**Addendum No. 3**

**RFT 26-030 Oakville #5 Elementary School & Child Care Facility**

**ADDENDUM NO. 3**

**Issued February 5, 2026**

GYPSUM BOARD BULKHEAD ENCLOSURE AT STAGE

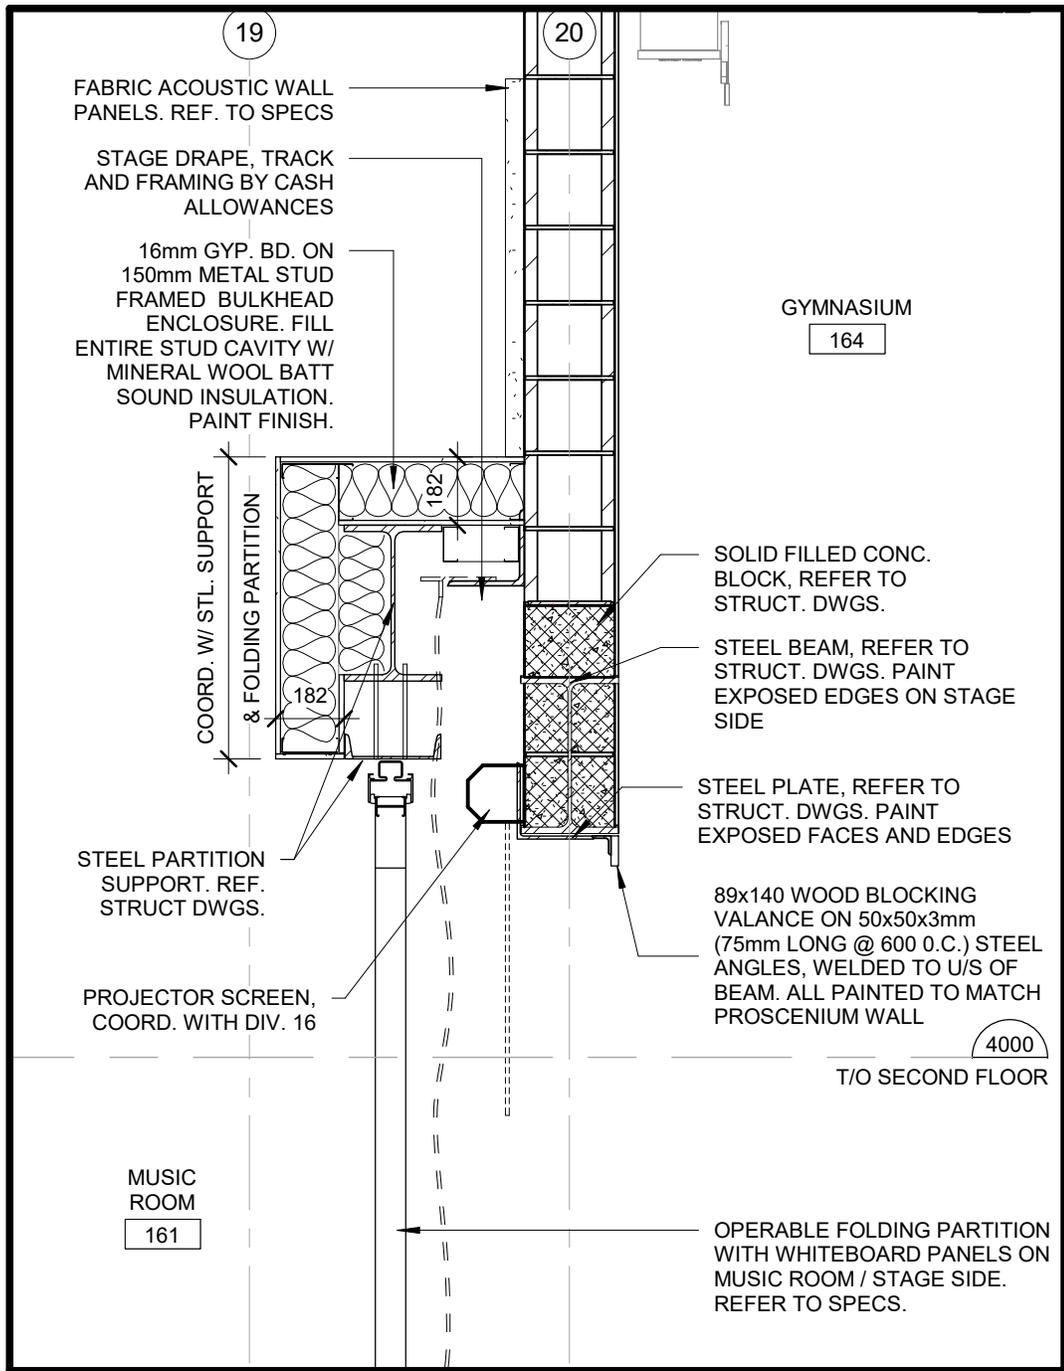
- .1 ADD Detail 7/A15 ‘Gypsum Board Bulkhead Enclosure at Stage’, per enclosed drawing SKA-3.

Sheet No: **LP.2 OF 2**

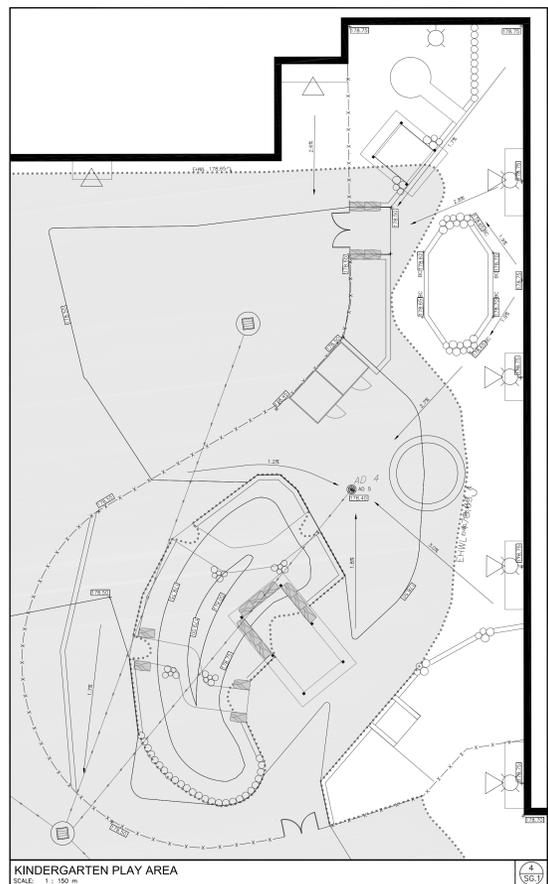
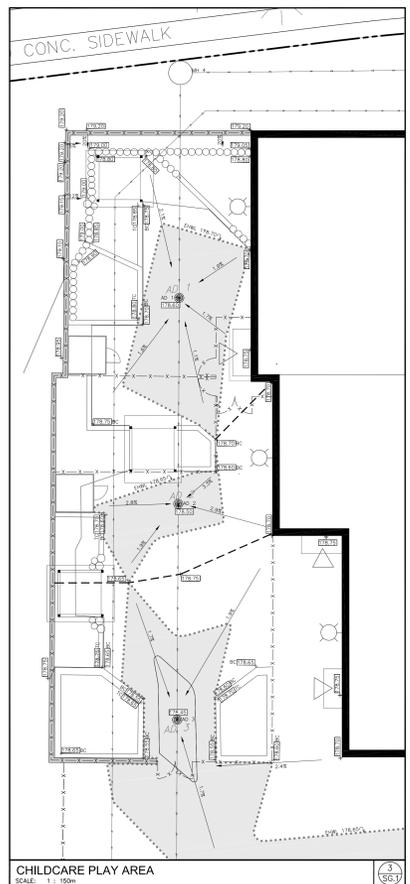
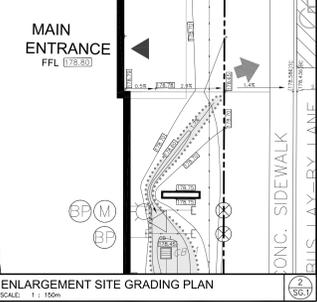
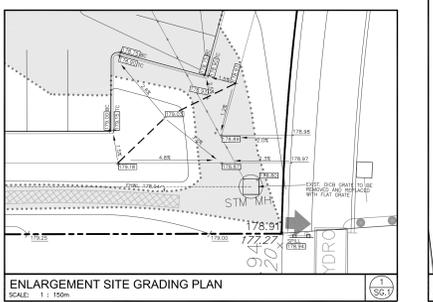
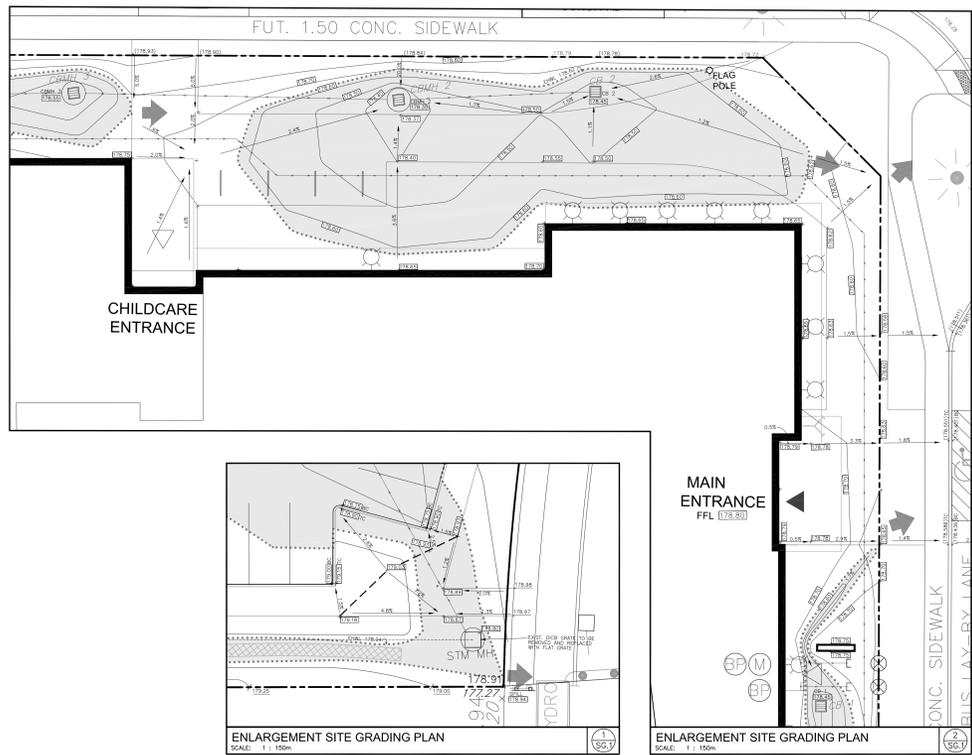
QUESTION 17: Drawing (2 / LP.2) – shows armour stone (8 / LP.2) by the cedar wood arbor. The typical detail for armour stone is (17 / LP.2). Please clarify if these armour stones are to be different than the typical armour stones as detailed in (17 / LP.2).

QUESTION 18: Drawing (2 / LP.2) – please confirm that the cedar wood arbor is to follow detail (3 / LP.2) as it is tagged (14 / LP.2).

QUESTION 24: Drawing (2 / LP.2) – shows (4) heavy duty galvanized stock tanks. Please provide a detail or supplier reference for the stock tanks.

ANSWER 17: [Refer to typical detail drawing 17/LP.2 'Armour Stone on enclosed LP.2 Daycare & Kinder Play and Details.](#)

ANSWER 18: [Refer to drawing 3/LP.2 'Cedar Wood Arbour' on enclosed drawing LP.2 Daycare & Kinder Play and Details.](#)

ANSWER 24: [Refer to enclosed drawing LP.2 of 2 Daycare & Kinder Play and Details.](#)

- .1 REPLACE: full size 36” x 48” drawing, ‘LP.1’ with enclosed ‘LP.1 LANDSCAPE PLAN AND DETAILS’.
- .2 REPLACE: full size 36” x 48” drawing, ‘LP.2’ with enclosed ‘LP.2 DAYCARE & KINDER PLAY AND DETAILS’.
- .3 REPLACE: full size 36” x 48” drawing, ‘SG.1’ with enclosed ‘SG.1 SITE GRADING PLAN’.
